Access Compliance Report Public Rights-of-Way (Curb Ramps)

Main Street: MCFADDEN_AVE		Cross Street: VAN_BUREN_ST		Location:	S
ADA ID: RPRK220202120214	Ramp Type: Type 4 - Parallel	Initial Pass/Fail: Fail	Overall Compliance: No	Severity Score:	16
Codes/Mitigation Info/Possible Solution			Field Measurements/Component Compliance

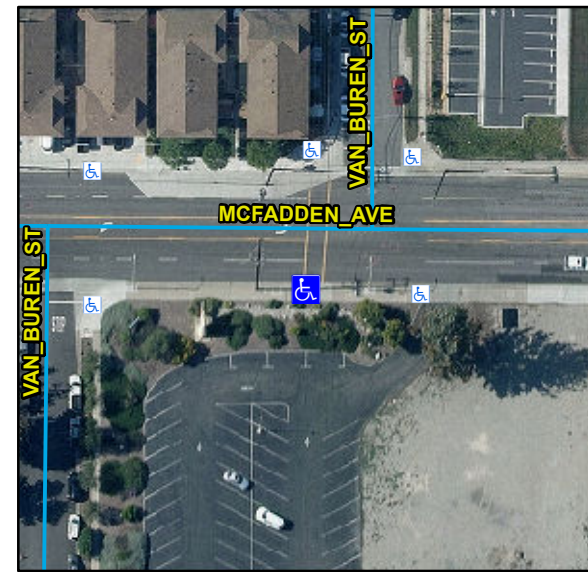
Compliance	Description	Data	Compliance	Description	Data
N/A	Ramp Length LT (in)	118	N/A	Ramp Length RT (in)	120
Yes	Ramp Width LT (in)	83	Yes	Ramp Width RT (in)	83
No	Ramp Run Slope LT (%)	9.3	No	Ramp Run Slope RT (%)	9.1
No	Ramp Cross Slope LT (%)	2.2	No	Ramp Cross Slope RT (%)	2.3
N/A	Landing Present	N/A	N/A	DWS Provided	N/A
N/A	Landing Length (in)	N/A	N/A	DWS Contrast	N/A
N/A	Landing Width (in)	N/A	N/A	DWS Length (in)	N/A
N/A	Landing Run Slope (%)	N/A	N/A	DWS Full Width	N/A
N/A	Landing Cross Slope (%)	N/A		DWS Offset Type	N/A
N/A	Landing Movement Obstructed?	N/A	N/A	DWS Offset Left (in)	N/A
	Landing Movement Type	N/A	N/A	DWS Offset Right (in)	N/A
N/A	Landing Shared	N/A			
N/A	Clear Space	N/A			
N/A	Clear Space To Crosswalk (in)	N/A			
N/A	Marked Crosswalk 1	Yes	N/A	Marked Crosswalk 2	N/A
	Crossing 1 Direction	N		Crossing 2 Direction	N/A
	Marked Crosswalk 1 Width (in)	144		Marked Crosswalk 2 Width (in)	N/A

Remove & Replace Entire Ramp.

R304.3.2, R304.5.3, STD 1115
